Appendix 2: CONSULTATION, FEEDBACK AND RESPONSES
Site Specific Management Plan 007 - Waikanae River
MacKays to Peka Peka Expressway
M2PP-121-D-MPL-0007

13 February 2014

COMMENTS ON PRELIMINARY ISSUE SSMP7: WAIKANA E RIVER

Waikanae River Crossing - Bridge Development Study MacKays to Peka Peka Expressway

PROPOSED PLAN- WAIKANAĒ RIVER BRIDGE - 1:500@A3

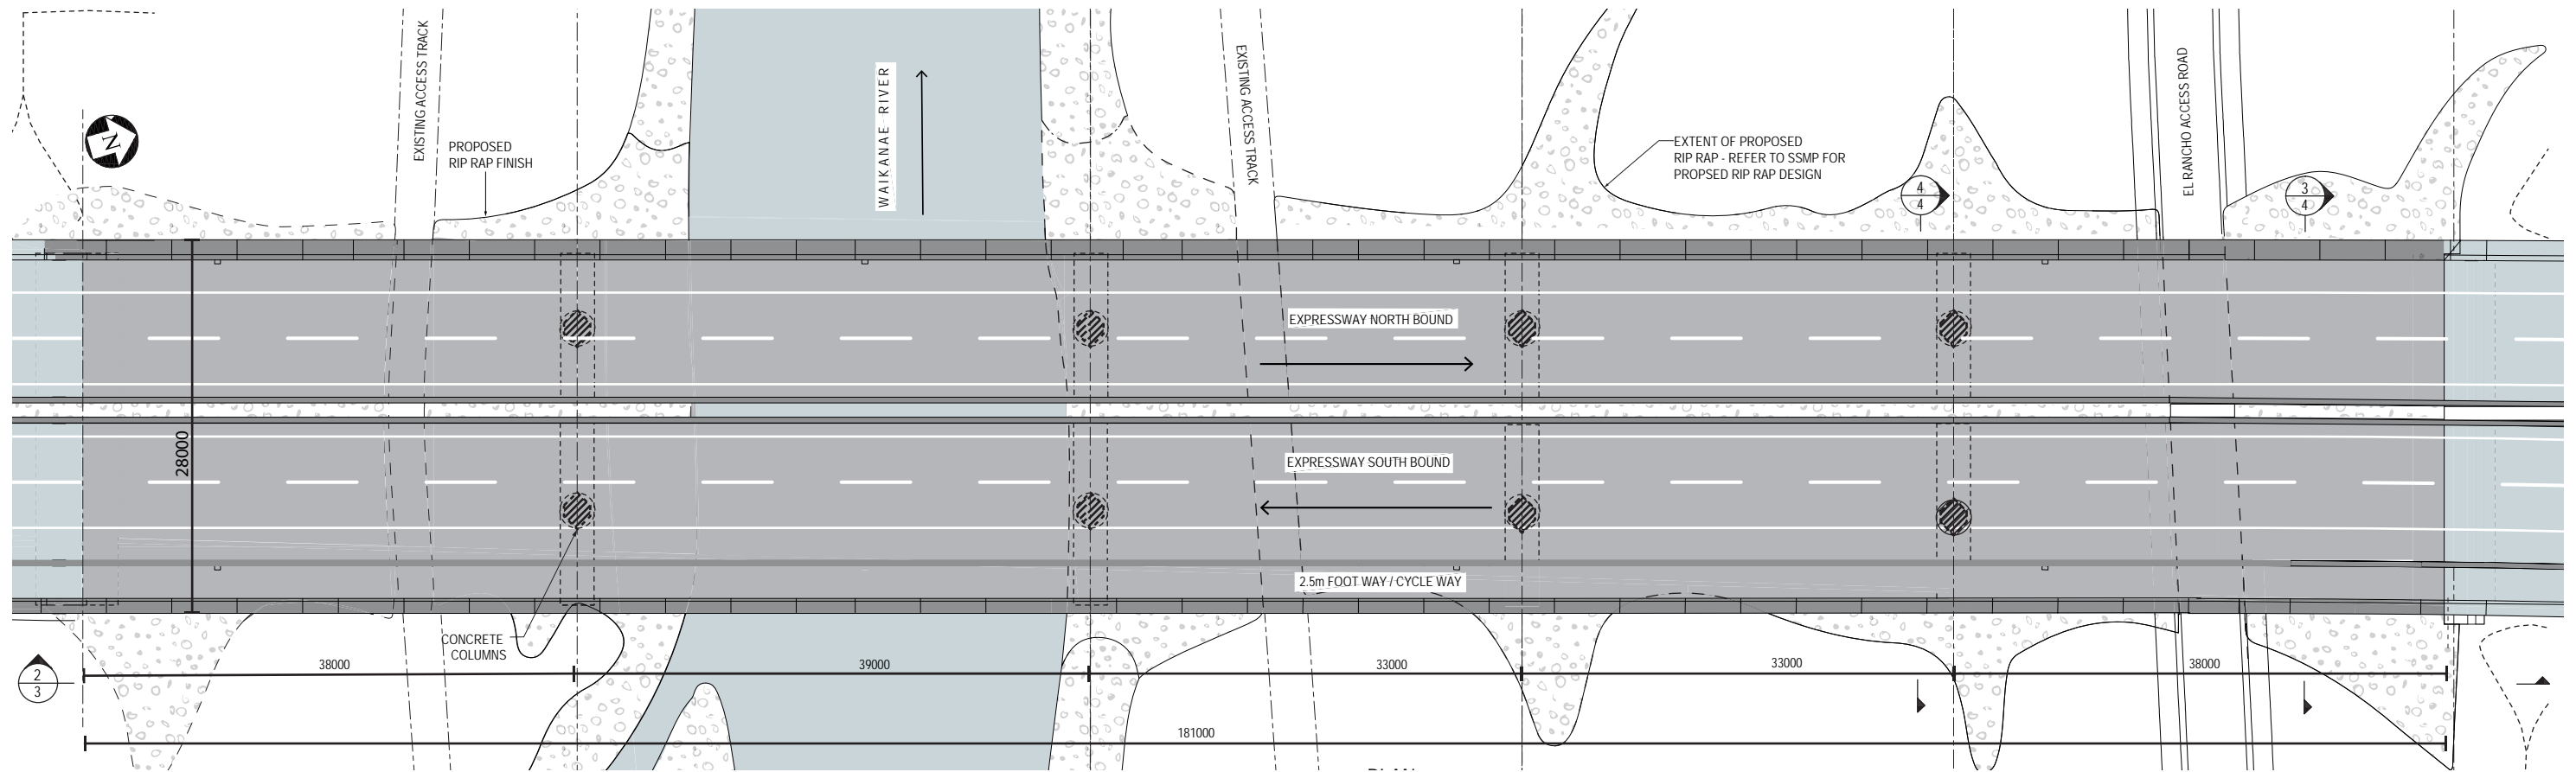
DC.7A, DC.57A & DC.59A	SSUDPs and SSLMPs must be consistent with the ULDF	JW/DP	UDLF 5.8.3 & 4: Inconsistencies. Greater level of detail is required to clarify the design in terms of quality and finish.		Changes to bridge forms as a result of detailed design process. Changes and rationale in relation to the ULDF set out in Appendix 3 Bridge Matrix
DC.57	The SSLMPs shall be consistent with the LMP	JW	LMP 8.54.2: Planting beside carriageway on southwest side of Expressway has native grasses as a transition at the edge. Clarify whether there is also an edge of gravel or grass directly adjacent to road – this is unclear on Sheet 16.	Sheet 16	Agree, this has been amended in the revised cross-sections to illustrate transition zone.

- 1. Split bridge (1m gap)
- 2. No exposed pile caps
- 3. Narrowed cycleway (3m to 2.5m)
- 4. Column profile developed
- 5. Rip rap design reflects river environment

- 1. Breaks up overhead structure, reduced beam numbers
- 2. No pile caps required (two piles/col, now 1 pile/col) improves columns interface with the ground plain.
- 3. Reduced beam numbers and deck area
- 4. Flattened diamond did not work seismically, hexagon provides improved structural core
- 5. Greater integration of bridge elements with local context. Reflects river environment
